Item Name: Replacement Exterior Window For -111

DRAWING NO. D3290	TITLE REPLACEMENT WINDOW ASSEMBLY	REV. C	DART AEROSPACE LTD ENGINEERING ORDER		D.E.O. NO. D3290-C-1	SHEET NO. SHEET 1 OF 1	SCALE NTS
DRAWN <i>JP</i>	CHECKED <i>JS</i>	MFG. APPR. <i>EZ</i>	APPROVED <i>MD</i>		DE APPR. <i>##</i>		
DATE 09.09.18	DATE 09.09.18	DATE 09.09.18	DATE 09/09/21		DATE 09/09/21

PURPOSE:

CHANGE MATERIAL THICKNESS OF D3290-1 FRAME TO 0.063 FROM 0.040. REF PAR 09-033.

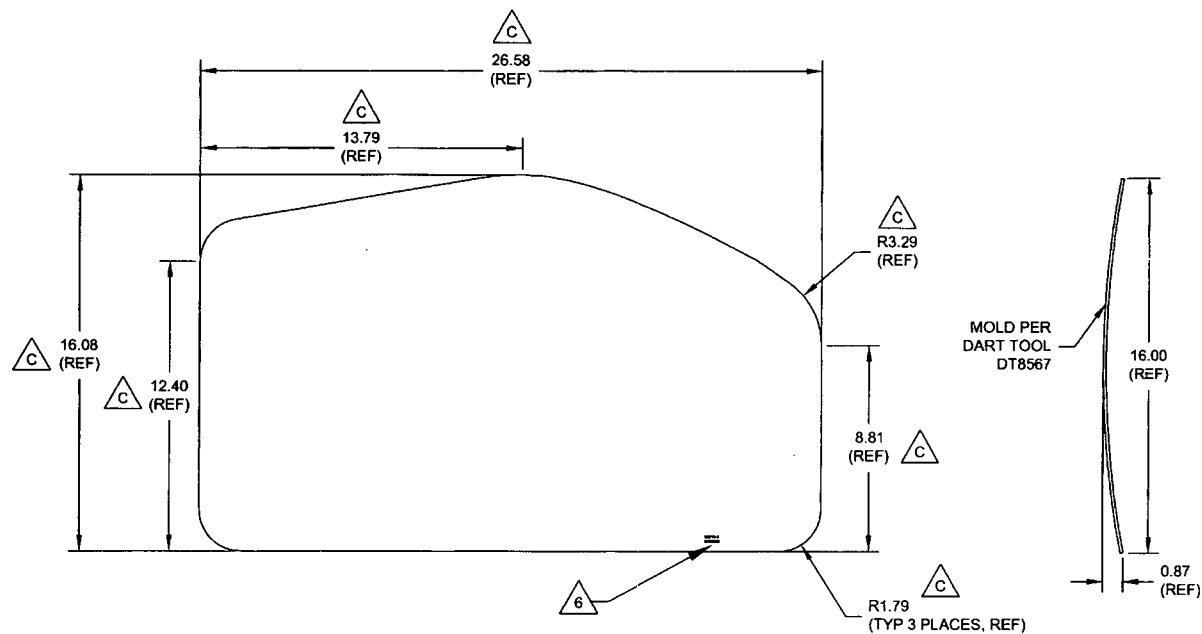
MATERIAL CALL-OUT OF D3290-1 FRAME ON SHEET 1 IS AMENDED AS FOLLOWS:

- 1) MATERIAL: 6061-T6 (OR 6061-T62) ALUMINUM SHEET ~~0.040 THICK~~ 0.063 THICK (REPLACE)
 PER AMS-QQ-A-250/11 OR AMS 4025 OR AMS 4027
~~(REF. DART SPEC. M6061T6S.040)~~ REF. DART SPEC. M6061T6S.063 (REPLACE)
 OR
 5052-H32 ALUMINUM SHEET ~~0.040 THICK~~ 0.063 THICK (REPLACE)
 PER AMS-QQ-A-250/8 OR AMS 4016
~~(REF. DART SPEC. M5052H32S.040)~~ REF. DART SPEC. M5052H32S.063 (REPLACE)
